Value Engineering Study Final Report

KY 15 north of Hazard
Kentucky Transportation Cabinet (KYTC)

Value Engineering Study
Item #10-269.20 VE202104

Perry County, Kentucky

**VE RECOMMENDATION NO. 1:
SHIFT KY 28 INTERSECTION TO THE SOUTH**

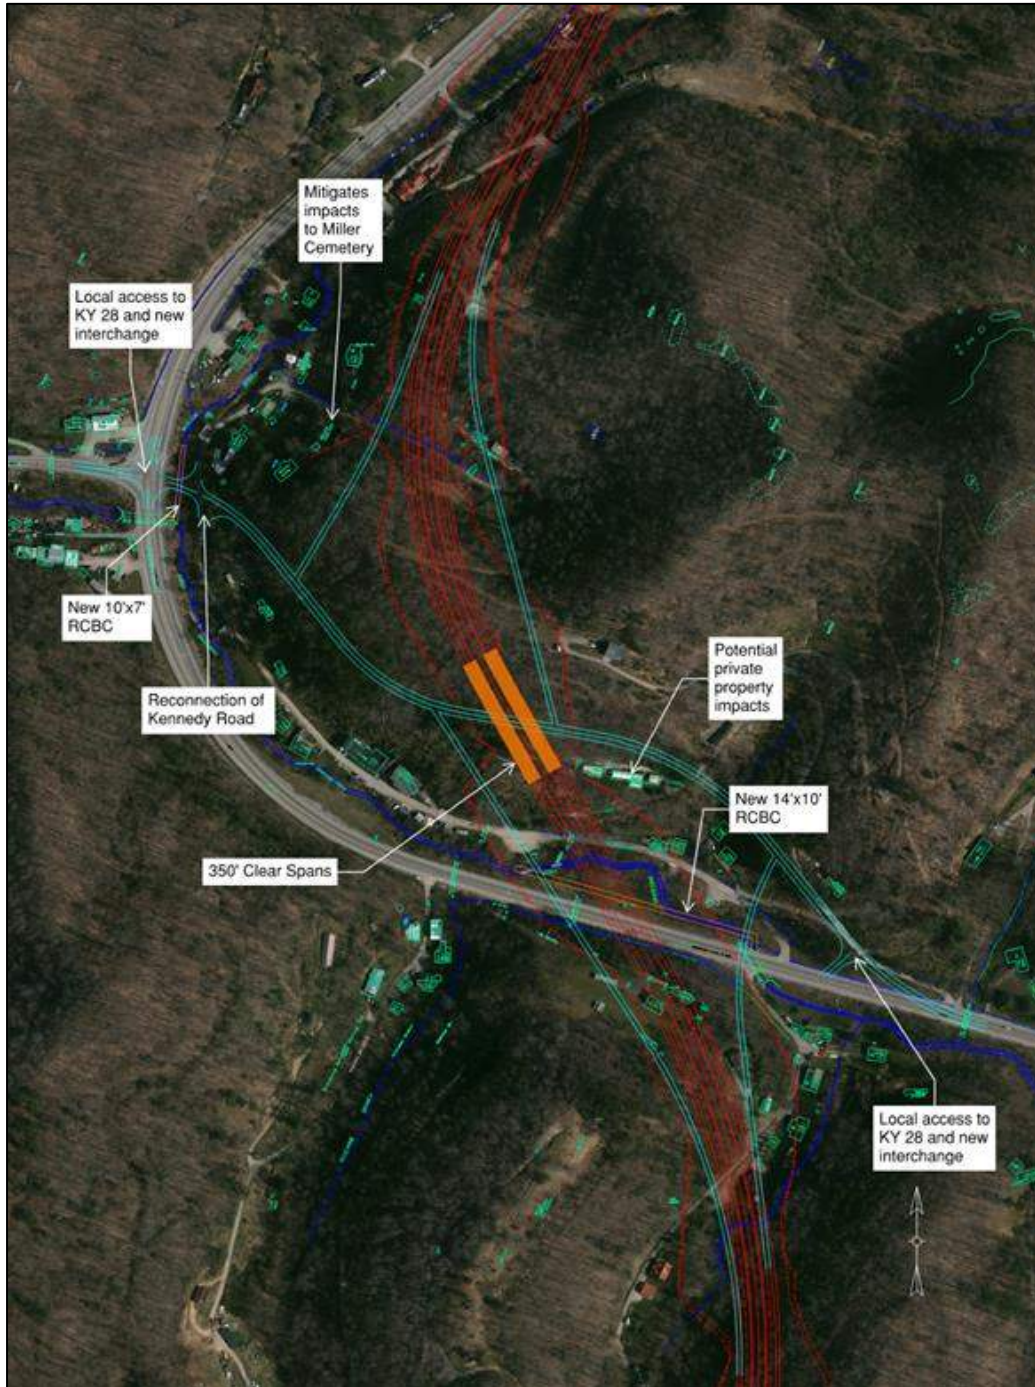
Baseline concept – Includes a proposed Tight Diamond Interchange for the intersection of KY 15 at KY 28. The proposed intersection would take the Tight Diamond Interchange into the side of the mountain to the east of existing KY 15 and extend KY 28 to the baseline alignment. This would also include a set of twin bridges carrying KY 15 traffic over KY 28.

**VE RECOMMENDATION NO. 2:
USE AT-GRADE INTERSECTION AT KY 28**

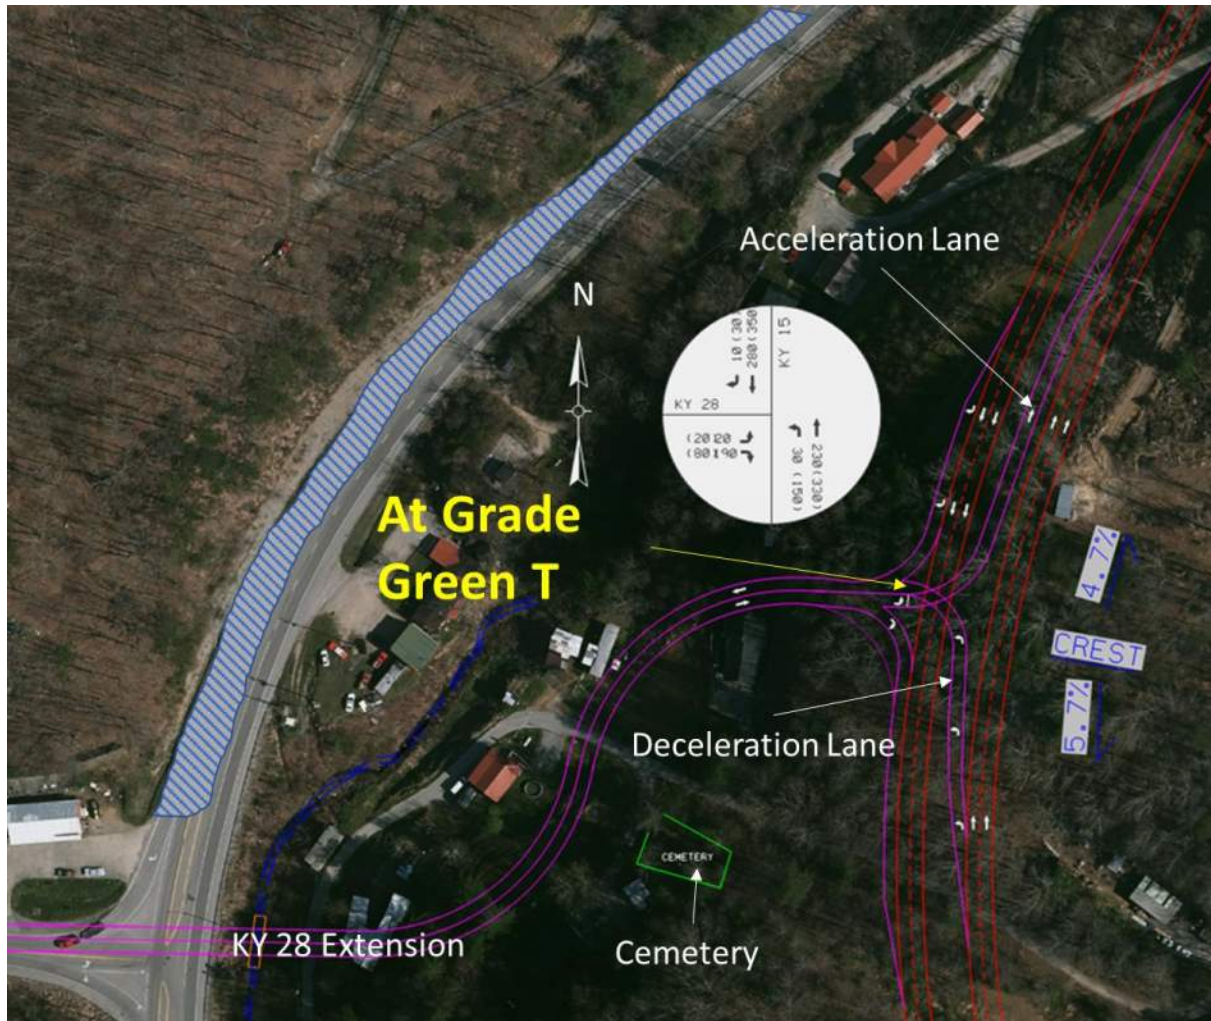
Baseline concept includes a proposed Tight Diamond Interchange for the intersection of KY 15 @ KY 28. The design calls for the Tight Diamond Interchange to be placed into the side of the mountain to the east of existing KY 15 and extend KY 28 to the baseline alignment. This would also include a set of twin bridges carrying KY 15 traffic over KY 28.

4 – LANE DEPRESSED MEDIAN (INITIAL 2+1 /ULTIMATE)

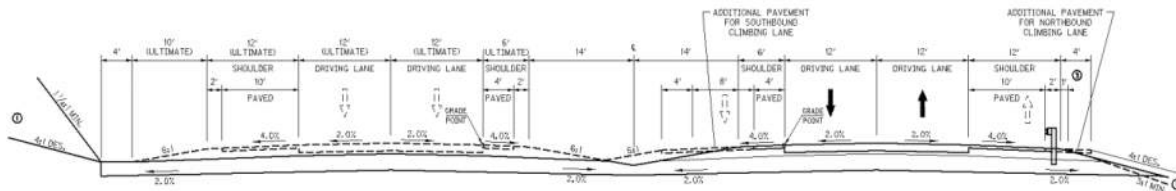
Initial (2+1)/Ultimate - This option includes constructing the necessary earthwork, excavation and purchasing the necessary right-of-way for the full typical section shown in the figure above, but only paving half the typical section and constructing one of the twin bridges. This would function as a 2-lane section with an alternating passing lane. This option would require additional full-depth pavement on the shoulders to accommodate traffic during the initial condition.

2+1 TYPICAL SECTION

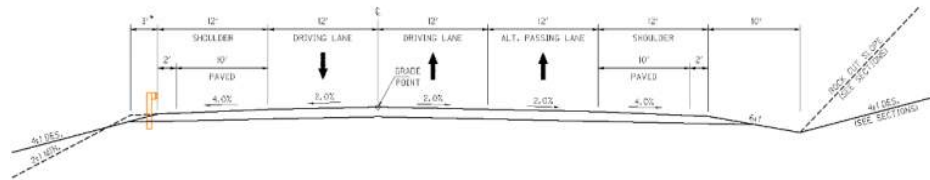
2+1 - This option includes reducing the typical section to a 2+1 typical section. This would function as a 2-lane section with an alternating passing lane. This option achieves the project goal of improving congestion and meets the operational requirements of traffic projections. This option reduces the number of bridges from a twin bridge at each grade separate to a single bridge which would reduce future maintenance cost.

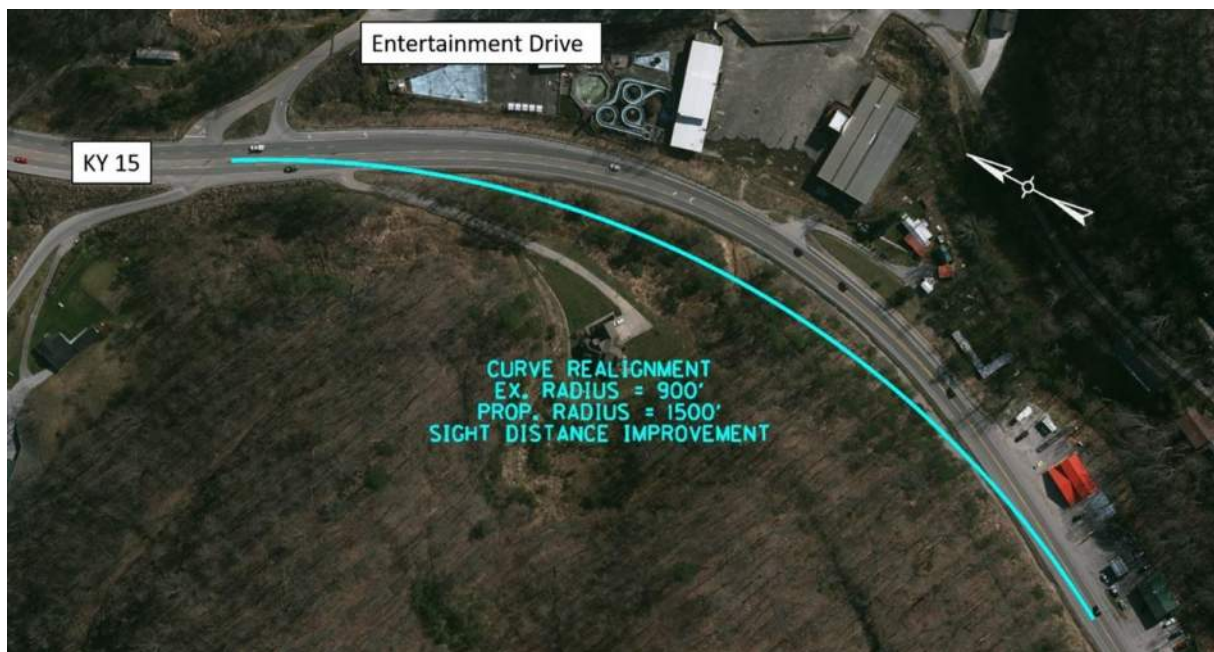
Consideration of existing utilities and additional R/W will dictate construction in this area. For purposes of this VE Study we will assume additional width to the existing cut slopes. Construction is generally accomplished by moving traffic to the outside shoulder and maintaining two-way traffic with temporary barrier wall placed along the cut shoulder to separate traffic from the excavation work taking place.

Substandard curves will be brought to current standards and may again require utility relocations and additional R/W. Construction should be straightforward as traffic will be maintained along current alignment with measures such as temporary barrier wall installed to provide separation between those traveling and workers.

Baseline Concept vs. Recommendation Concept for Option A

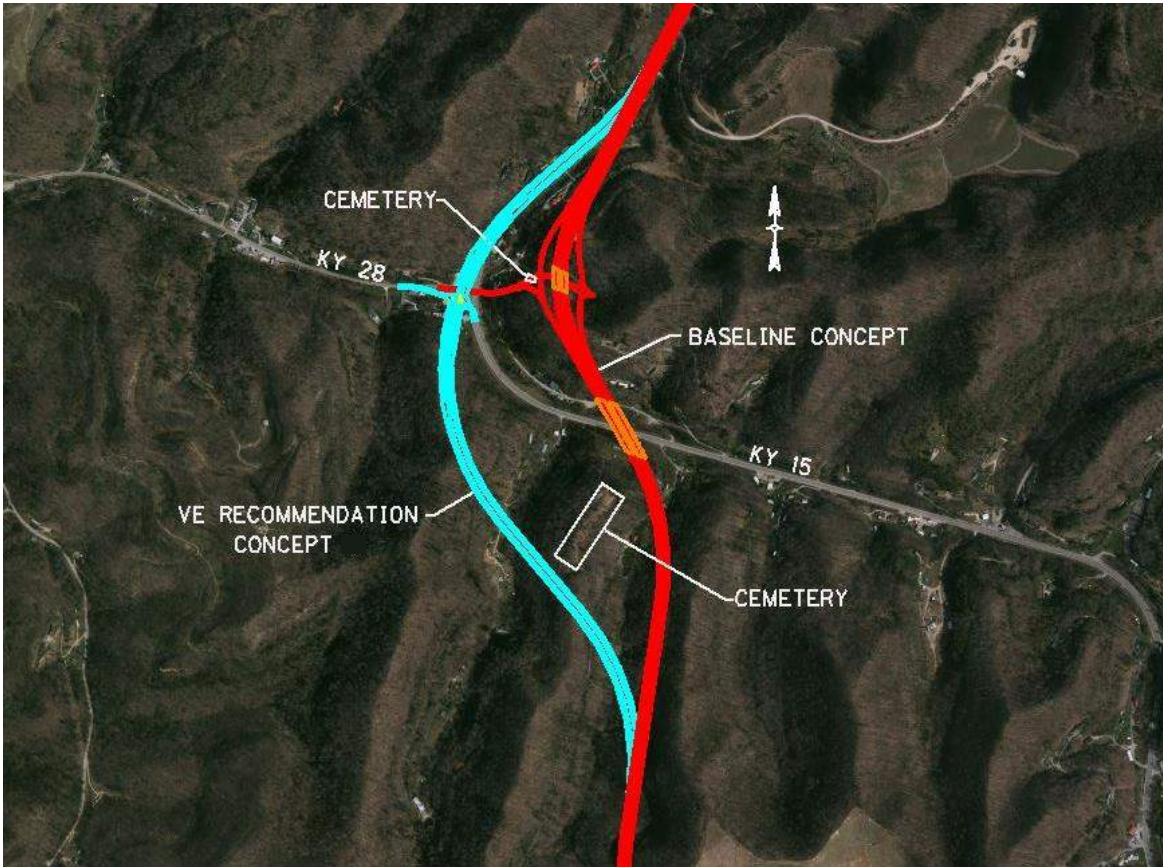
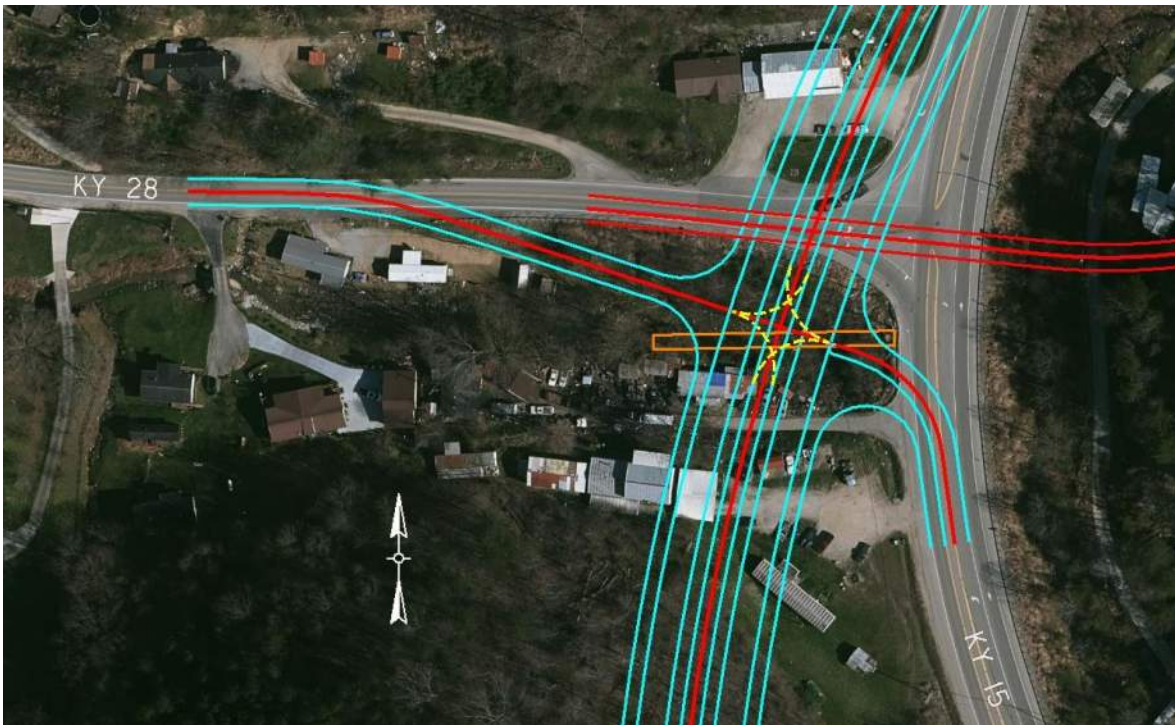
The recommendation concept would use the majority of the baseline concept's new alignment of KY 15, but would modify the radius of the horizontal curve to shift the alignment to the west of an existing cemetery south of the existing KY 15. This would convert KY 28 and KY 15 to an at-grade 4-legged intersection. This would eliminate the need for the set of twin bridges which are currently needed to cross existing KY 15 near Martha Lane. This recommendation would also

Option A might also require additional features, such as the use of a high friction surface to address 6% super elevation. The VE Team is assuming the modified radius (cyan curve) would be constructed at the correct super elevation. If so, then there might not be a need for the high friction surface. Depending on the grade at the KY 28 tie-in into the 6% super elevation, high friction surface could be used at the KY 28 intersection or the design team could reduce the 6% super elevation by using a high friction surface and increasing the friction factor. The VE Team did not have enough information available regarding the proposed change to the baseline, we were unable to quantify if high friction surface would be needed, but wanted to state it.

Option B

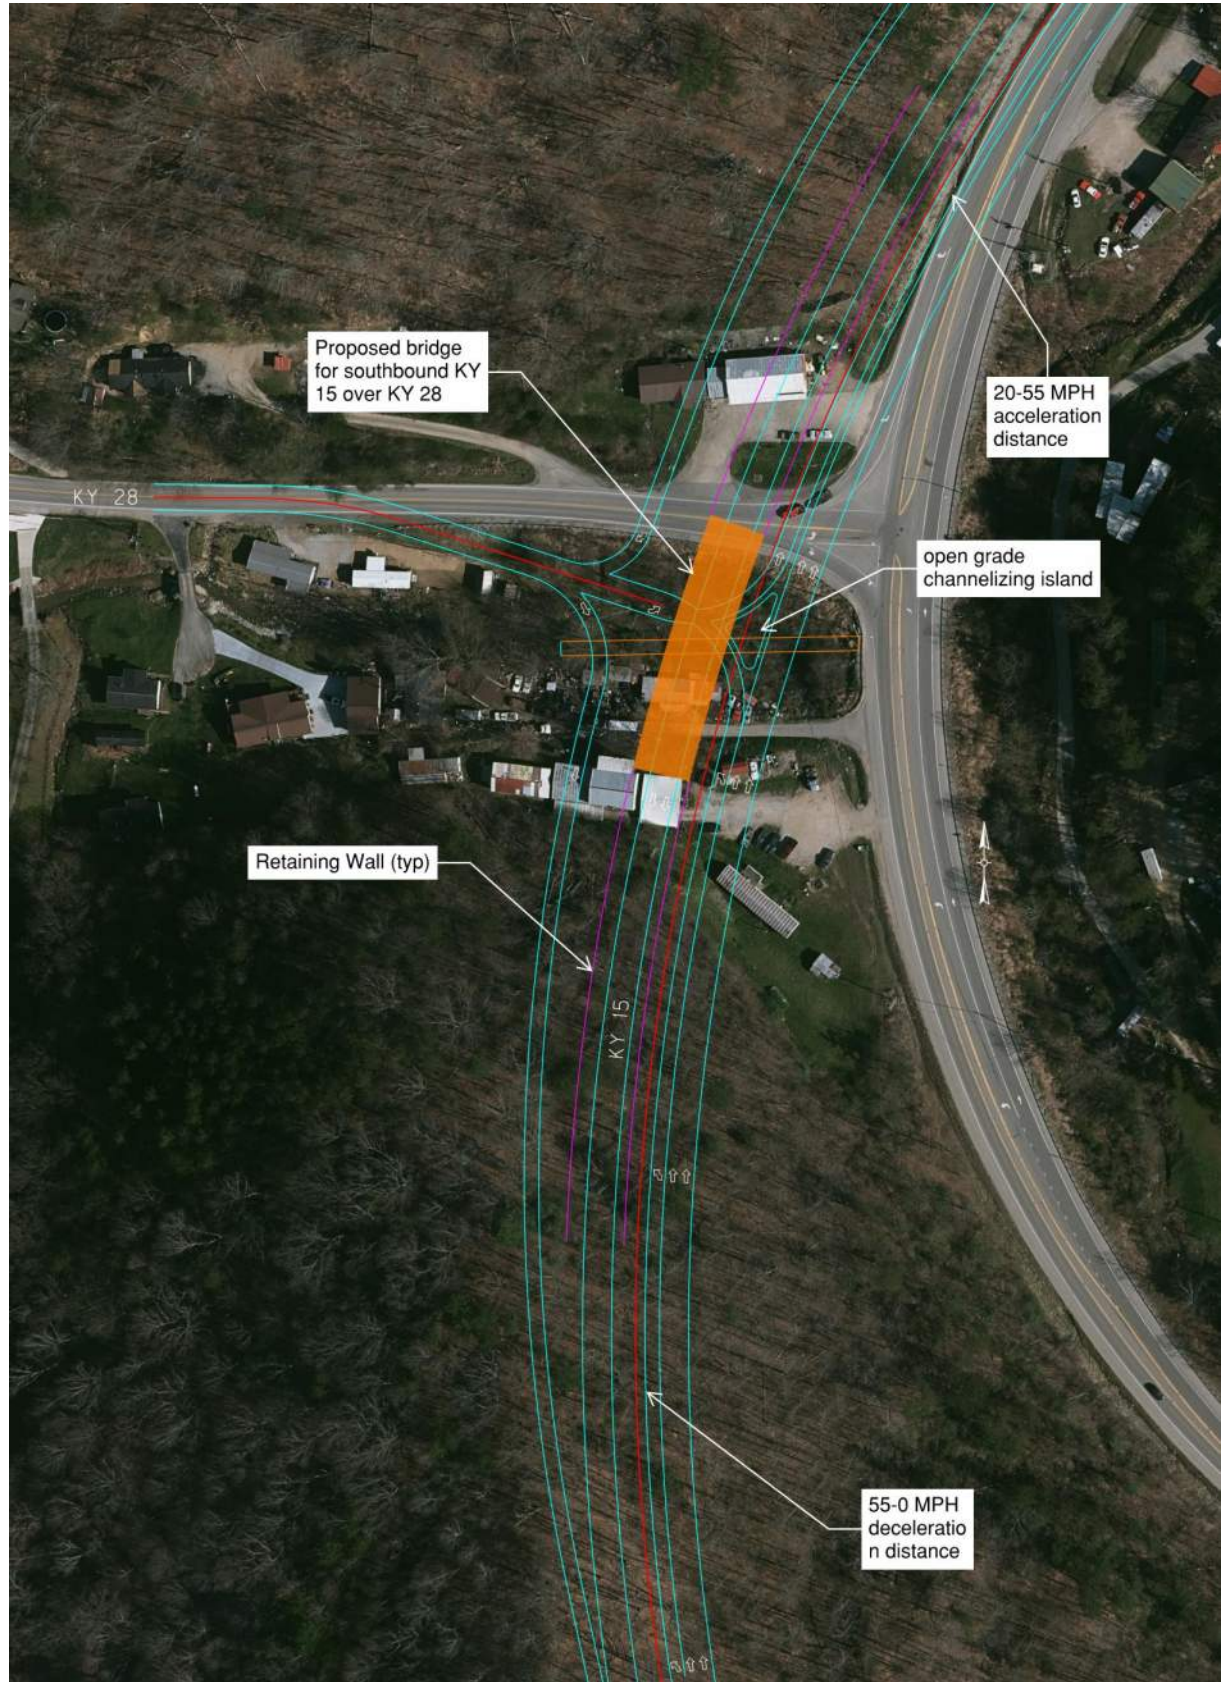
Option B is to provide a continuous high green T-intersection (CHGT) at KY 28 and KY 15. This will provide free flow through movement along the KY 15, with NB KY 15 at grade and SB KY 15 elevated over KY 28. The benefits of a CHGT are as follows:

- Provides uninterrupted flow for all through movements along the arterial
- Reduces conflict points

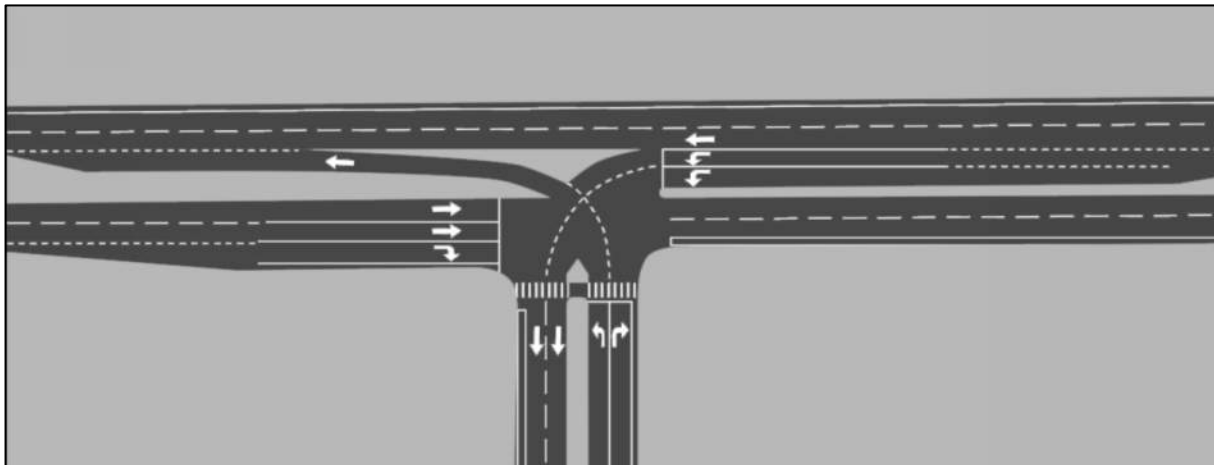
A Continuous Green T-intersection (CGT) channelizes left-turn movement from the minor street approach onto the main arterial, along with a continuous arterial through movement that occurs at the same time. This results in reducing conflict points and improving overall traffic flow at the intersection. Refer to the KYTC Congestion Toolbox at [Continuous Green T | KYTC](#) and the general layout of a CGT below.

To further enhance a CGT, the roadway of the opposing through movement on the mainline can be elevated. This will provide free flow through movement along the mainline, with one direction being at grade and the other being elevated over the minor street. This is referred to as a CHGT since one direction of travel is elevated. The benefits of a CHGT are as follows:
